Product Name:	HPL – 629	
	Microspeed RA Combo	
Product Manager:	Chen Bruce	
Subject:	Notification of Planned Change	
Distribution:	Affected customers	
Type of Change:	Location Change	
Change Description:	1. Addition of new stamping and plating capability and material localization for Amphenol Nantong site. 2. Localization with alternate materials for the Combo connection plate. Change of contact material from C75700(CuNi12Zn24) to C75200(CuNi18Zn18)	
Reason for Change:	1. For capacity enhancement, the component can be sourced from existing Amphenol FCI Besancon France site and locally in China for Amphenol Nantong site. 2. To mitigate shortage of contact raw materials, introduced alternate similar material source.	
Affected Parts:	See Affected Parts.xls	
Effective Date of Change:	October,15 2026	
Last Time Buy Date:	NA	
Earliest Disty Return Date:	NA	
Last Time Shipment Date	NA	
Datasheet Attached?	Yes

Material comparison verification

-- Microspeed Combo connector
10147075

Retention force comparison

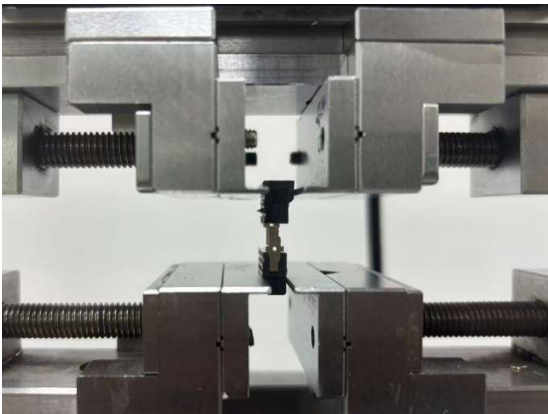
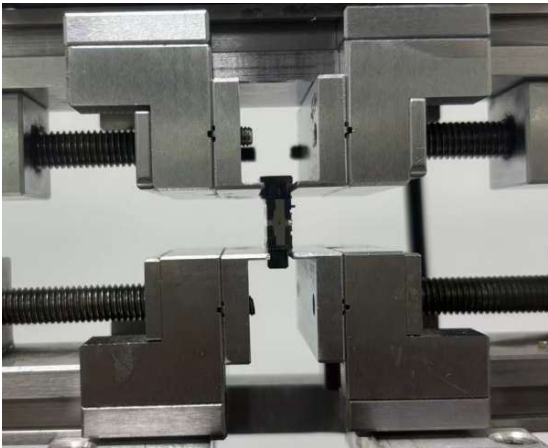
On Combo connection plate, the raw material is C75700 (CuNi12Zn24), we checked with Wieland, the lead time is 6 months with 5 Ton MOQ,
So we'd like to recommend another similar material C75200 (CuNi18Zn18), see attachments for the material data sheet comparison.

item	C75700(current) (CuNi12Zn24)	C75200 (new) (CuNi18Zn18)
1	18.20N	20.00N
2	17.20N	19.10N
3	17.50N	18.90N
4	18.90N	20.30N
5	19.30N	17.90N
Avg	18.22N	19.24N
Min	17.20N	17.90N
Max	19.30N	20.30N
